# UNITED STATES PATENT AND TRADEMARK OFFICE

### Office Action Summary

10/524,888

RUEB, FRITZ ALFONS

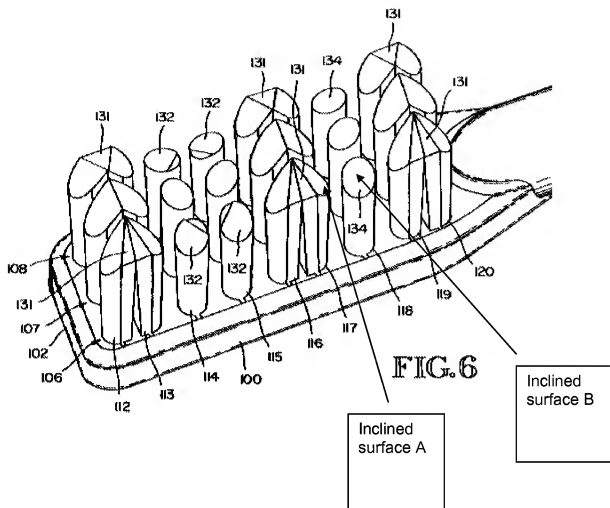
Claims 1,2,4-6 and 8-11 are rejected under 35 U.S.C. 102(b) as being anticipated by Underwood et al (USP 6,035,476). The patent to Underwood discloses (with particular reference to figure 6) a toothbrush comprising a body (100) as well as a plurality of tufts the free ends of which are all beveled (some of which define plural beveled surfaces). In an effort to identify the portions of the bundles in Underwood, applicant's attention is directed to the figure below.

Claim 1 at present only requires that “some” (which could be as little as two) of the bristle bundles have an inclined as defined in the claim and that the adjacent bundles have an inclined surface oriented relative to each other at an angle other than 90 and 180 degrees. As defined in claim 1, inclined surface A of one bundle and inclined surface B of another adjacent bundle are oriented relative to each other at other than 90 and 180 degrees.

1. The examiner has attempted to identify two inclined surfaces of adjacent bundles in figure 6 of Underwood which seem to be oriented at angles other than 90 or 180 degrees relative to each other. The claim at present only requires SOME (which could be as little as two) having the recited inclined surface(s) which are thus oriented as defined in the last three lines of claim 1. The claim does not preclude the presence of additional bundles or inclined surfaces thereof which have a different orientation.
